Aylesham Parish Council Response – Draft Canterbury District Local Plan

Policy R1 - Land at Cooting Farm

Land at Cooting Farm – concept masterplan

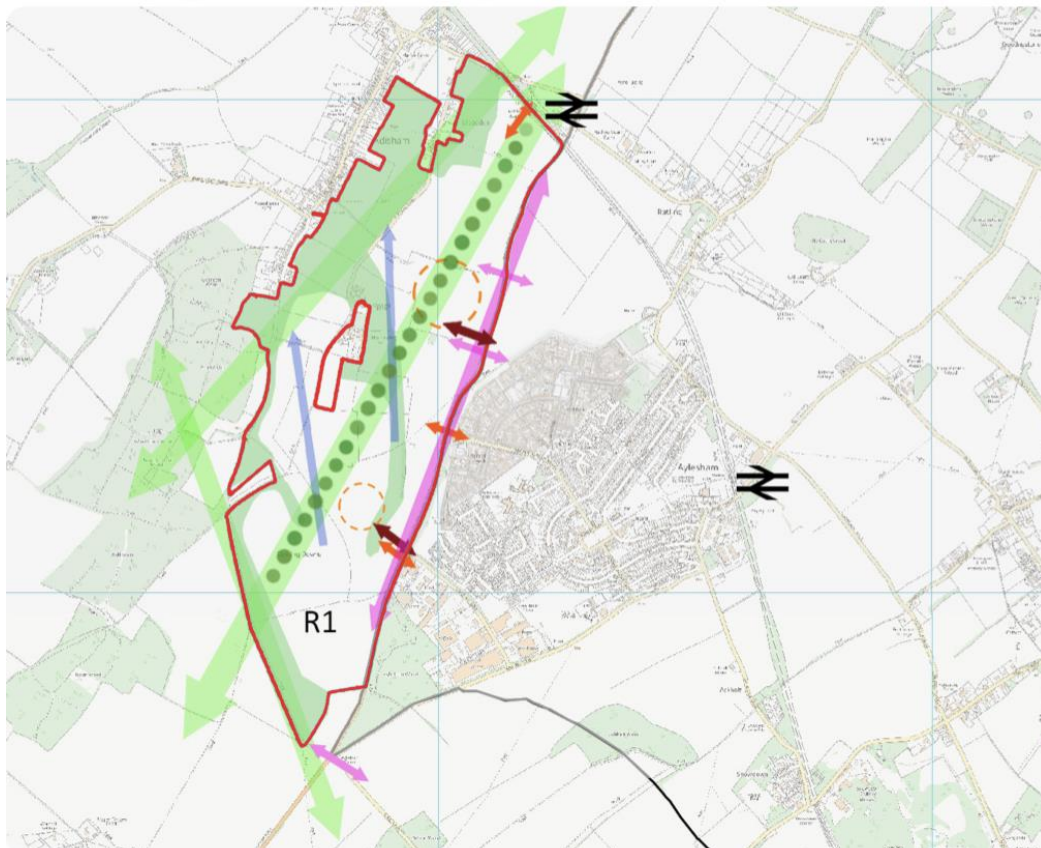
2.3 From the indicative image (above), a number of arrows can be seen: red arrows showing opportunities for cycle/walking access to Aylesham and the burgundy arrows showing approximate locations for new road access. It is unclear yet in what style this access will be.

2.4 The dotted green line shows active travel corridor, and the shaded green area is a proposed open space/biodiversity zone.

2.5 As well as the 2 primary schools, a secondary school is mentioned if this is considered necessary and could be onsite. There is, however, no mention of nursery provision. Kent County Council's Sufficiency Assessment 2021 identifies Adisham area having a deficit of nursery places, which is also the case for Aylesham. This is a failure of the local plan to ignore this issue.

THIS DRAFT LOCAL PLAN MUST MAKE PROVISIONS FOR CHILDREN UNDER THE AGE OF 5 AS THE LOCAL AREA IS KNOWN TO HAVE A DEFICIT OF CHILDCARE PLACES.
